Office Action Summary

10/718,832

HE ET AL.

DETAILED ACTION

Figure 5A-5F
50
11

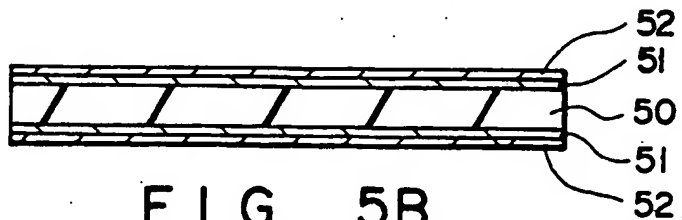
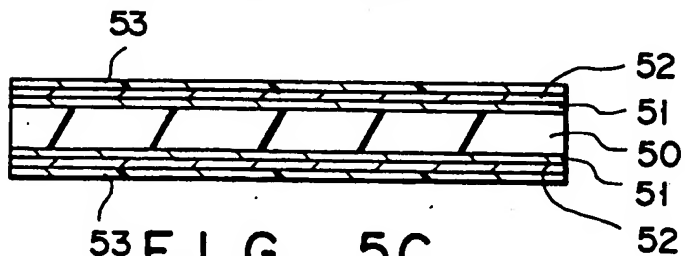
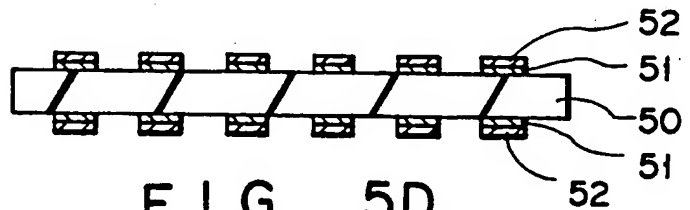
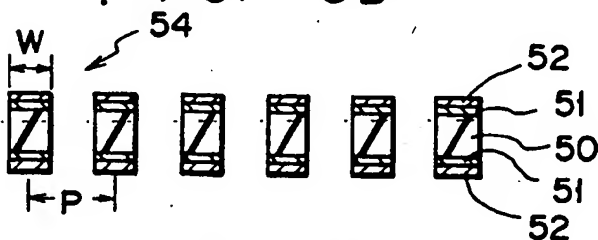
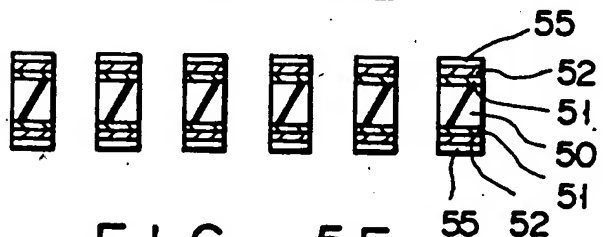
Ikeda et al teaches etching a quartz plate 50. (Figure 5)

The motivation for etching a quartz substrate in the apparatus of Jucha et al is to provide an etching apparatus in which to form the probes taught by Ikeda et al.

The motivation for optimizing the mixture of gases such that the ratio of plasmas results in an etching rate across the substrate within 1% of the rate of etching at the central portion of the substrate is to improve the uniformity of the etching process which results in a more uniformly etched substrate as taught by Ikeda et al.

Therefore it would have been obvious to one of ordinary skill in the art at the time the invention was made to manufacture the probes of Ikeda et al in the apparatus of Jucha et al.
